**Subject** Helipad Sound Management Plan Peer Review  
Maine Medical Center - Portland, ME  
Acentech Project No. 631363

At your request we have conducted a peer review of the Sound Management Plan (SMP) for the proposed changes to the helipad serving Maine Medical Center (MMC) in Portland (the project). This letter presents our comments, which are based on the SMP, the documents provided to us by MMC (including the Final SMP), as well as a phone conference with MMC and Russel Acoustics.

Figure 1. Mean measured DNL, summer 2018

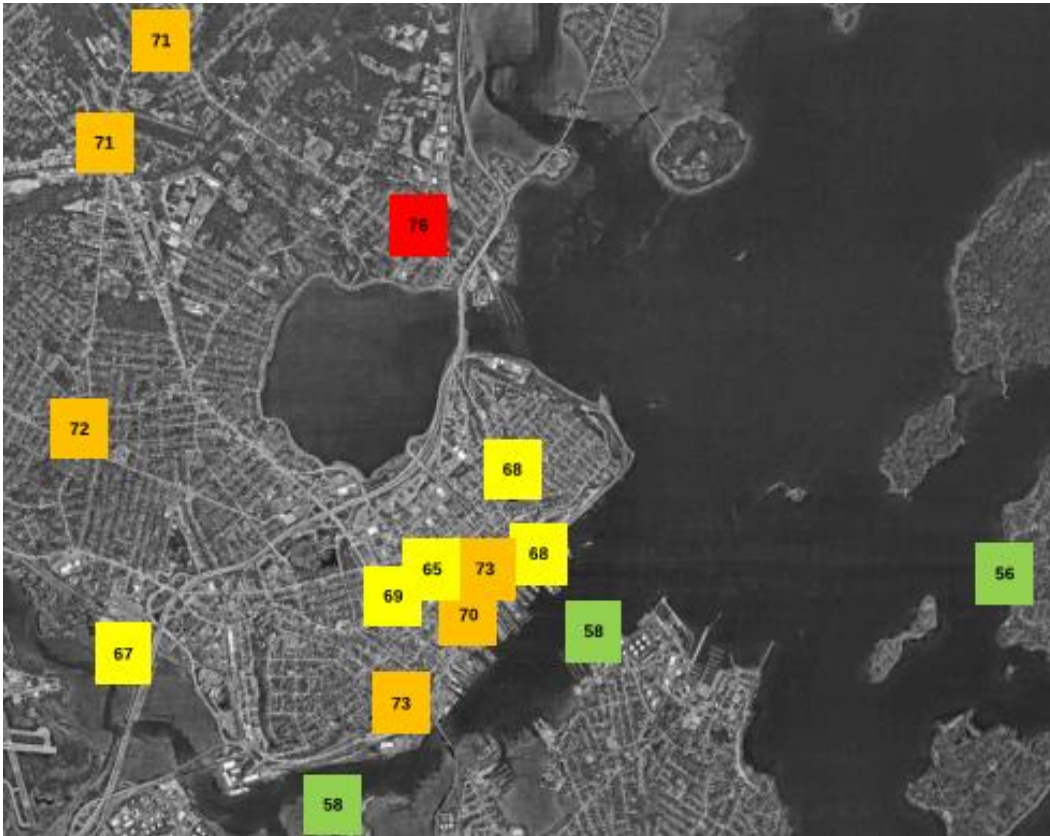
On behalf of the City of Portland, Acentech conducted a 3-month survey of existing sound levels at 13 locations in the City (as well as 2 locations in South Portland) during the summer of 2017. The mean DNL are shown in Figure 1. Our work product for this survey is part of the public domain, and we would be pleased to share it at your request.

The mean measured DNL throughout the City proper were in the range of 65 to 76 dBA, and levels at the monitoring stations nearest the existing helipad were about 70 dBA. Our spatial mapping of the measured DNL does not indicate a particularly noisy area in the vicinity of existing helipad operations or flight tracks. Rather, it suggests that long-term average noise levels in the vicinity of the project are relatively uniform and spatially homogenous.
